AGENDA
PLANNING AND ZONING COMMISSION MEETING
CITY OF CREVE COEUR, MISSOURI
TUESDAY, FEBRUARY 18, 2020
6:30 PM

1. PUBLIC HEARING. Application #20-001: Amend The Conditional Use Permit And Site Concept Plan, And Approve A Site Development Plan For A New 28,000 Square Foot Basketball Arena At Chaminade College Preparatory School

**APPLICATION TO PLANNING AND ZONING COMMISSION
#20-001: AMEND THE CONDITIONAL USE PERMIT AND SITE
CONCEPT PLAN, AND APPROVE A SITE DEVELOPMENT PLAN FOR A
NEW 28,000 SQUARE FOOT BASKETBALL ARENA AT
CHAMINADE COLLEGE PREPARATORY SCHOOL**

Figure 2: Proposed East Elevation

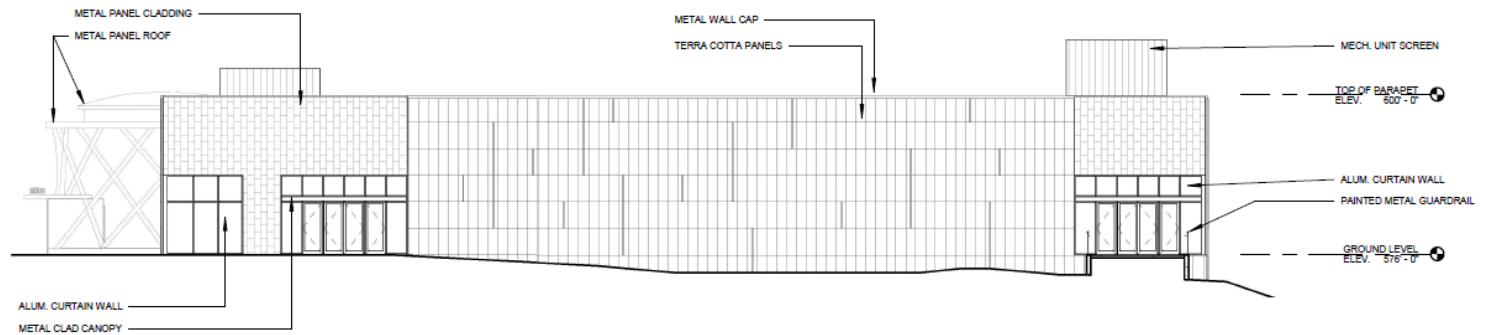
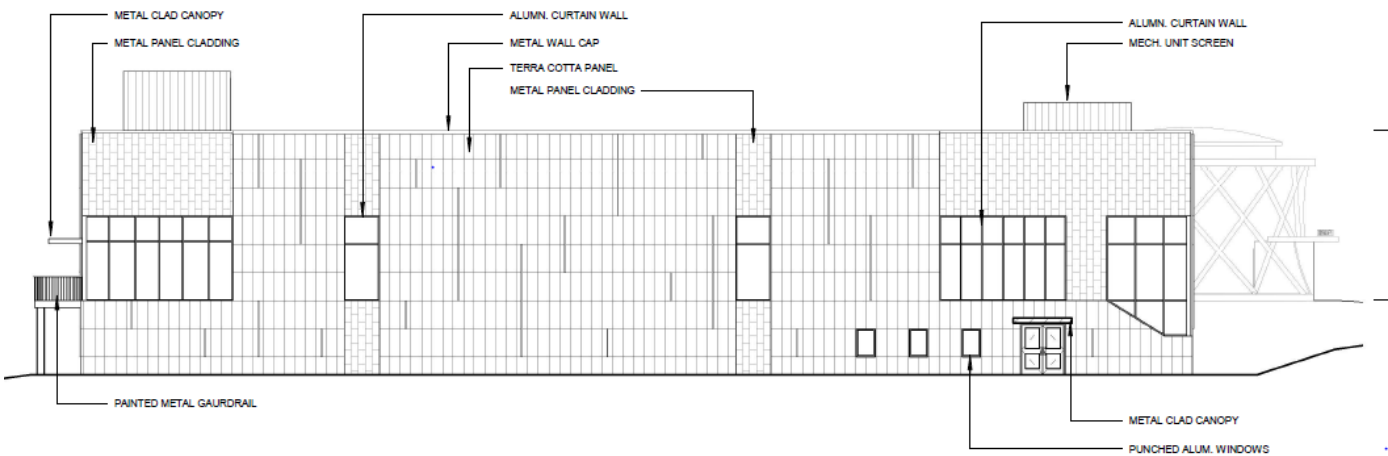
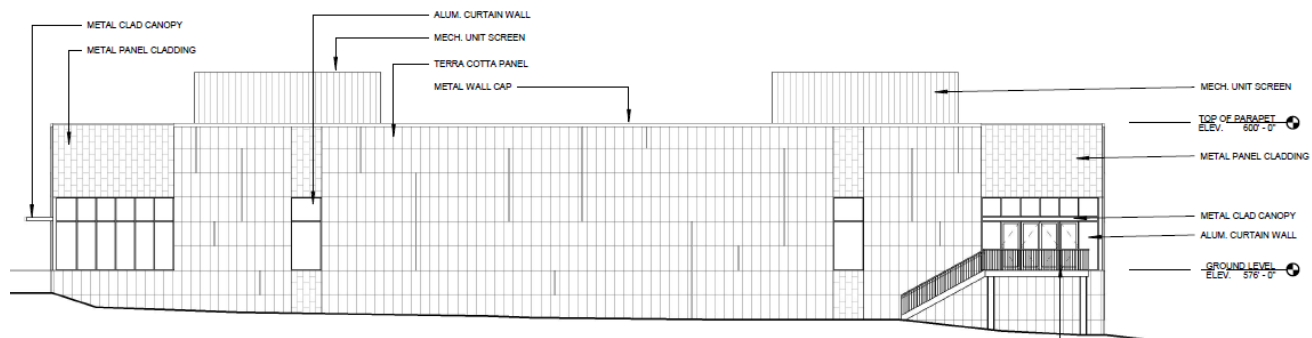
The elevations also indicate a prominent roof top mechanical equipment screening. The Design Guidelines state that Building elements, such as parapet walls, penthouses or screen walls should be treated as an integral part of the architecture, incorporating similar design, detail and materials as the

primary structure. All rooftop equipment, including, but not limited to, satellite and other telecommunication equipment, air handling units, elevator equipment, cooling towers and exhaust fans are to be screened from view. Building screens should be part of the architectural design with similar detailing and materials and not appear as add-ons. The Architect has indicated that the roof slopes down toward the front elevation and the equipment sits lower and should be mostly screened from view. The screening will be most visible from the back of the building. The mechanical screening is a lighter grey color to add into blending into the sky. However, no detail or color sample of the mechanical screening has been provided.

Landscaping

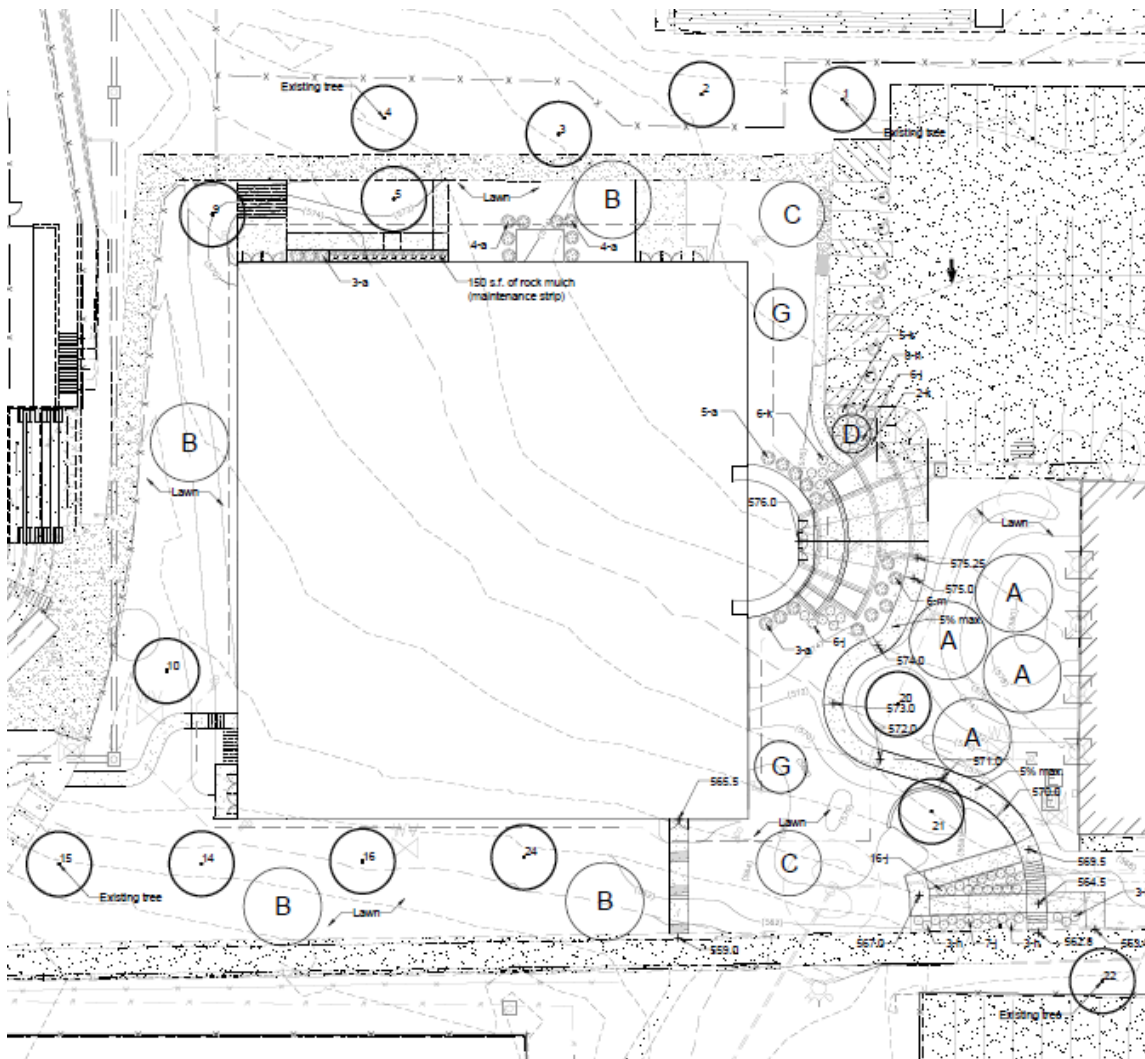
The new facility will require the removal of 10 trees as identified on the tree census, of the Landscape Plan. The Landscape Plan shows the addition of 11 canopy-shade trees, and 2 understory-ornamental trees, a flowering dogwood, along with some shrubs along the main entrance and adjacent to the building.

3. The Applicant shall submit a landscape plan in substantial conformance with the drawings received February 5, 2020 as bound together and submitted in conjunction with Application #20-001 by Audrey O'Hagan, Architect, and Sterling Co. Engineers & Surveying.

Figure 9: Close-up of the site plan showing the Accessible Parking spaces adjacent to the new Arena.

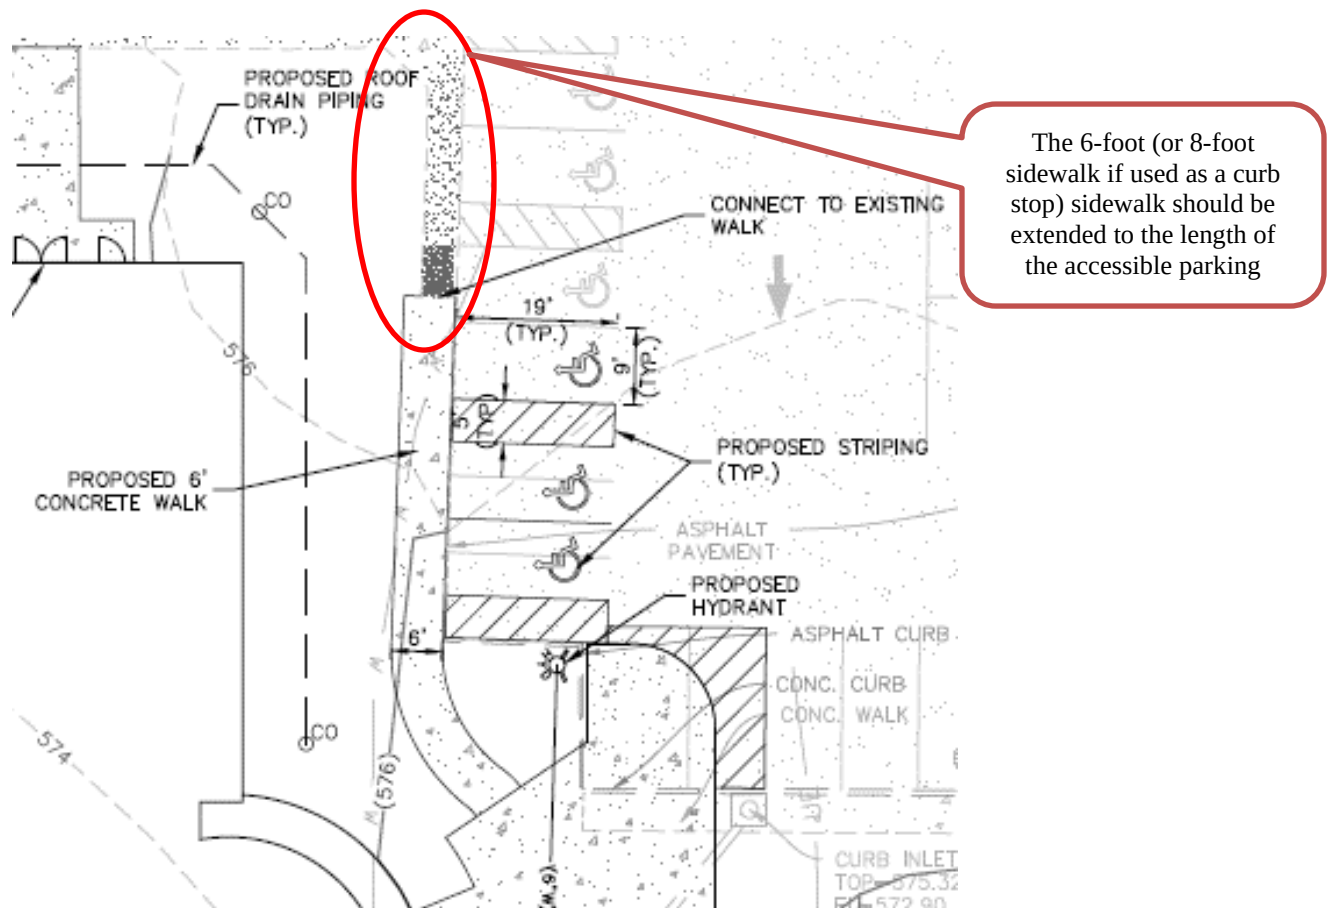
Section 405.730(A)(2) requires that the minimum width of internal sidewalks in non-residential developments shall be at least six (6) feet or eight (8) feet if used as a curb stop. The proposal includes the reworking of a few of the spaces within the parking lot. The drawings indicate that for the three new accessible parking spaces that the sidewalks are 6 feet, and will connect with the existing non-conforming sidewalks that are 4 feet in width, Staff has included a condition of approval that the new walkway should be a minimum of 6 feet, or 8 feet if used as a curb stop, and that it should be extended down the length of the Accessible parking spaces as shown below:

6. The new sidewalk along the Accessible Parking spaces shall be a minimum of six (6) feet, or eight (8) feet if used as a curb stop, and shall be extended north to the full length of the accessible spaces, per Section 405.730(A)(2) and as discussed in the Staff report for the Planning and Zoning meeting of February 18, 2020.
